**Fw: UEC Tx amendment**  
**Ray Leissner** to: charles.maguire  
Cc: Stacey Dwyer, Philip Dellinger

Re: Amended Request for Approval of Non-Substantial Underground Injection Control (UIC) Program Revision to Establish an Aquifer Exemption in the Goliad Formation, Goliad County

## A PLAT OF:

AQUIFER EXEMPTION AREA FOR:

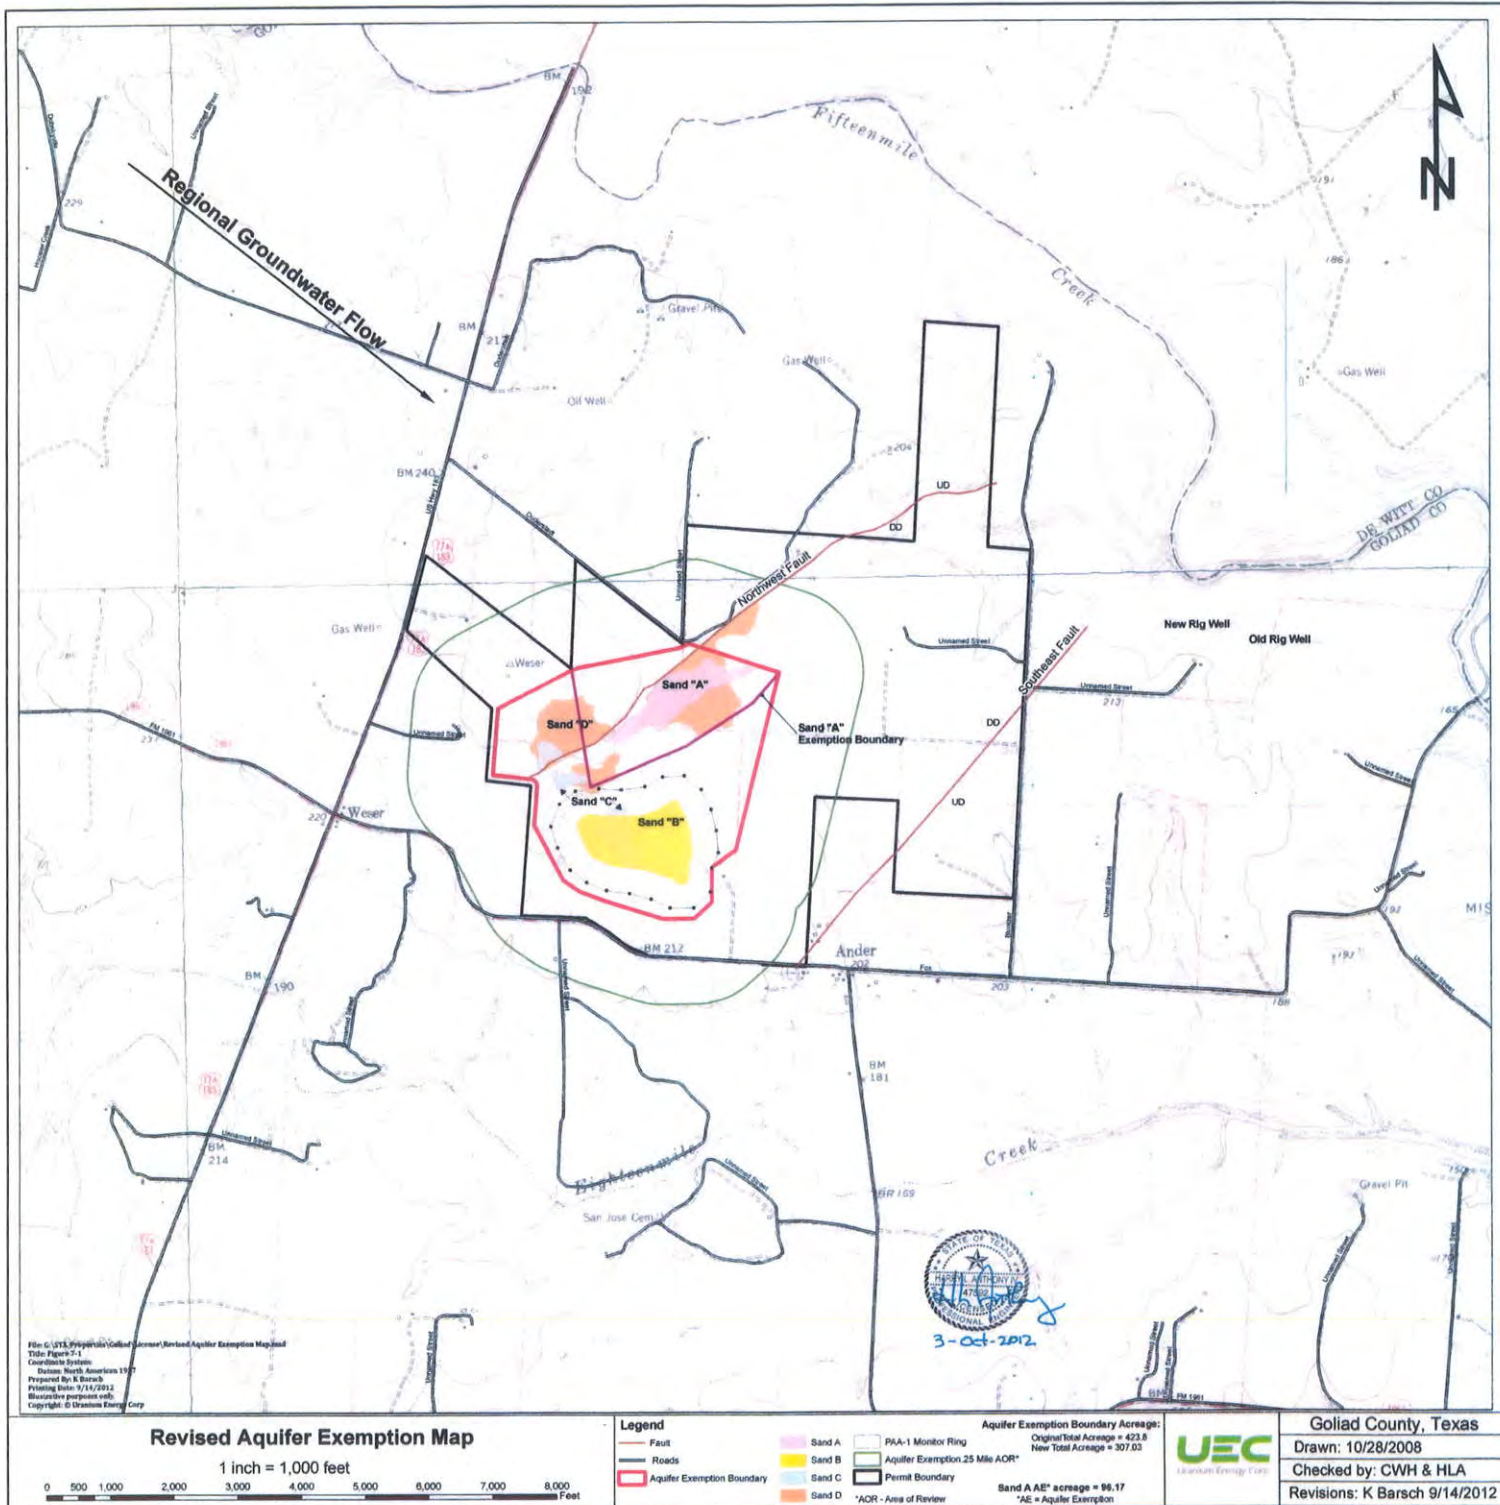
The exempt area for Sand A be reduced from 423.8 acres to 96.17 acres; and

The exempt area for Sand B, Sand C, and Sand D be reduced from 423.8 acres to 307.03 acres.

In the exempt area for Sand A, the exemption will extend for a depth of 45 feet to 110 feet. In the exempt area for Sands B, C, and D, the exemption will extend from a depth of 110 feet to 404 feet. A copy of UEC's correspondence and a map of the revised area are enclosed. UEC explains that approximately 117 acres have been removed from the original exempted area for Sands B, C, and D, and 327.63 acres have been removed from the original area for Sand A and that private water wells within the buffer zone surrounding the revised area are not capturing groundwater from the designated exempted aquifer. The revised and reduced portion of the aquifer is completely within the exempted aquifer approved by the TCEQ on April 29, 2012; no additional portions of the aquifer are proposed to be exempted. Although the TCEQ does not consider this
